PUBLIC NOTICE AND AGENDA OF THE GROVELAND LOCAL PLANNING AGENCY
MEETING SCHEDULED TO CONVENE AT 6:30 P.M., MONDAY, MAY 2, 2016, IN THE PURYEAR
BUILDING AT 243 SOUTH LAKE AVENUE.

| AGENDA ITEM: Rockers Lockers Site Plan |

AGENDA ITEM: Resolution 2016-05-11 – Variance to Landscaping and Architectural Details – Rockers Lockers

PLAN NAME: Rockers Lockers – Green Valley Lots 3-5
Site Plan Review
PLAN NUMBER: Application No. 2015-86

BUILDING 2 – WEST ELEVATION

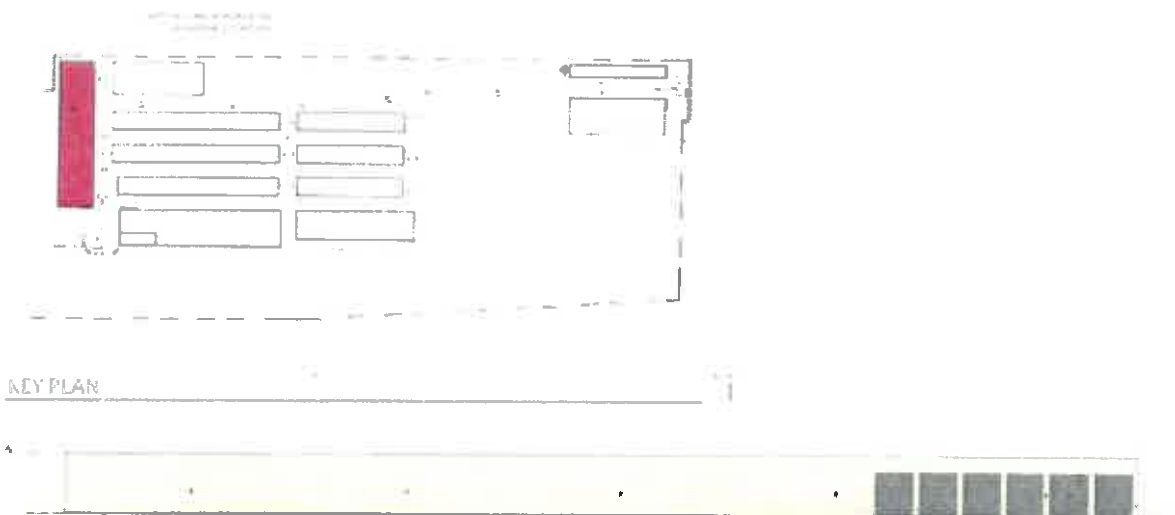
4. The following are visible from SR 50, other public right of way, and may be visible from adjoining properties' public space: Building 2 - West Elevation, Building 8 – East Elevation, Building 11 -North Elevation, Building 13- South Elevation. Therefore, each must meet the

Building 2 – West Elevation: The applicant indicates it will be blocked by landscaping; however, applicant states nothing but shrubs can be planted for the western boundary line, which will have a reduced perimeter buffer. If the landscape variance is granted, and the shrubberies used do not grow must in height, then the combined effect of the western elevations' lack of architectural details and lack of sufficient landscaping may result in an unattractive view.

Building 2 West will be blocked by our landscaping and the development on lot 6.

BUILDING 8 – EAST ELEVATION

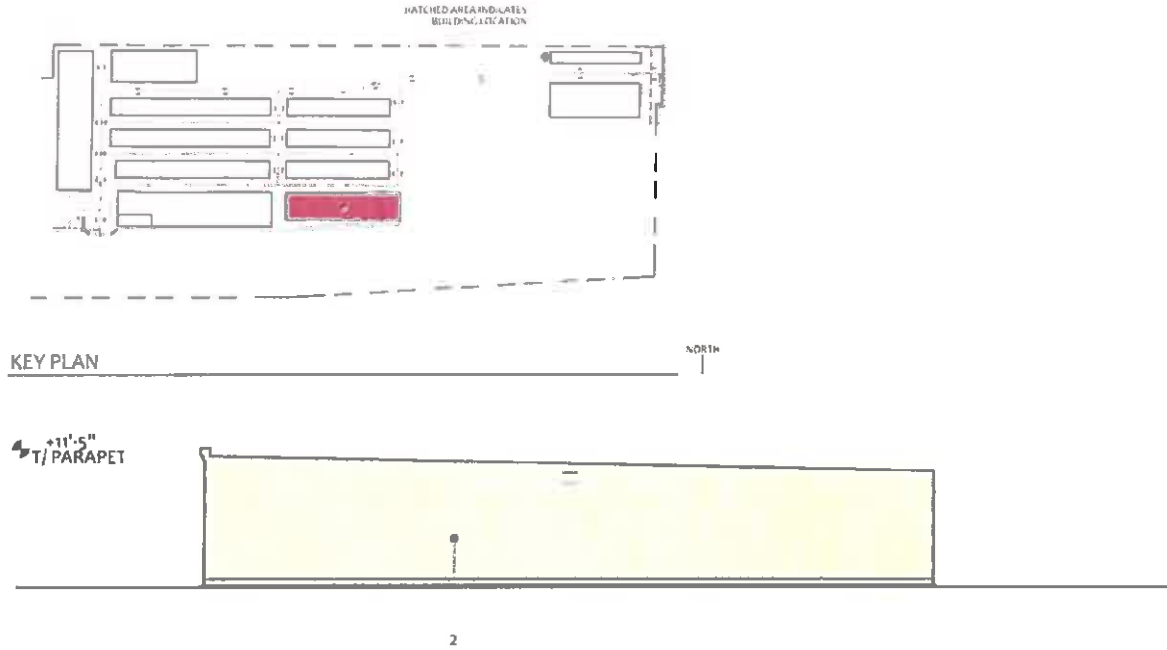
Building 8 – East Elevation: Each project site is required to meet the code and future off-site landscaping and future development is speculative as to when construction will occur, what will be constructed, what variances/waivers the owner will seek, etc.

Building 8 East will be blocked by our landscaping and the development on lot 2.

BUILDING 11 – NORTH ELEVATION

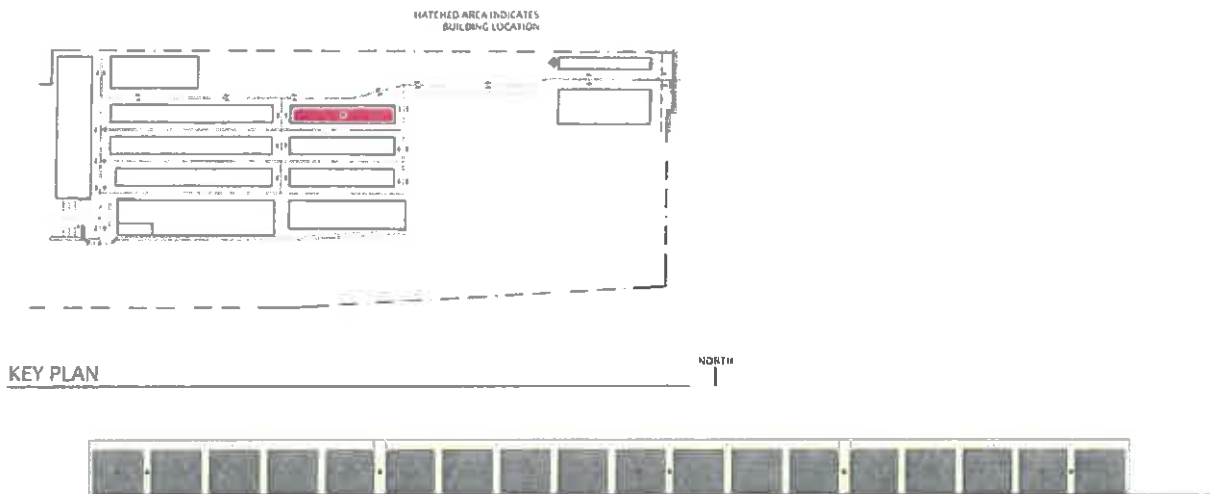
Building 11 – North Elevation: is visible from Magnificent Lane and the Green Valley Townhome project.

Building 11 is internal to the site and has the retention area and landscaping to block view. Building 13 South will be blocked by our landscaping and the development on lot 1.

BUILDING 13 – SOUTH ELEVATION

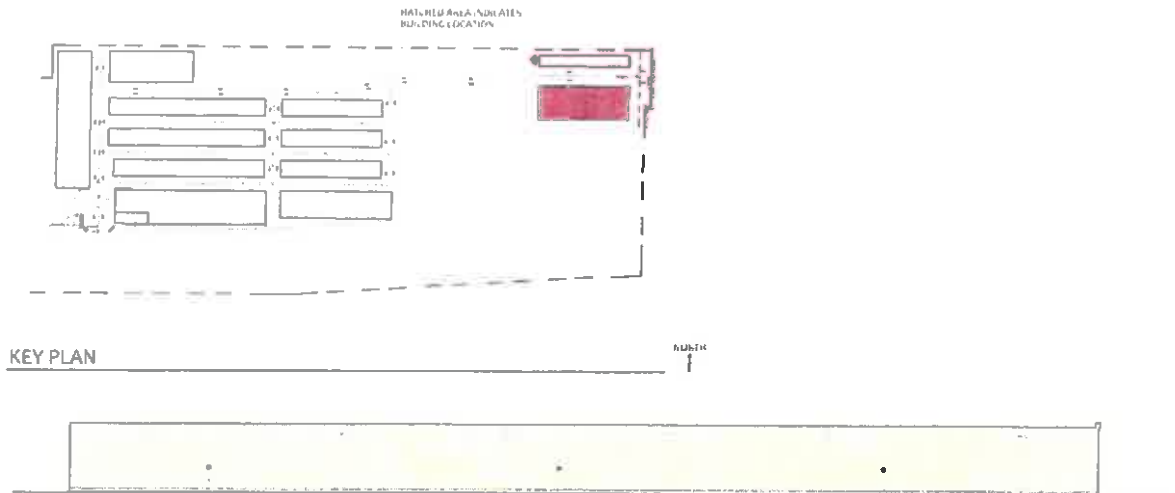
Building 13 = South Elevation: There is only a 2' landscape buffer along the southern boundary where Building 13 is located. Each project site must meet the code.

Regarding Sides 2 West, 8 East and 13 South (see attached) which the site is higher than State Road 50, there is landscaping that blocks view of the site, along with after buildout Lots 6 and 3 which will have views blocked from the west, east and south. Elevation 11 North is separated by the internal road, retention pond, property landscaping, and both the roadway and landscaping at the Green Valley Townhomes subdivision to the north.
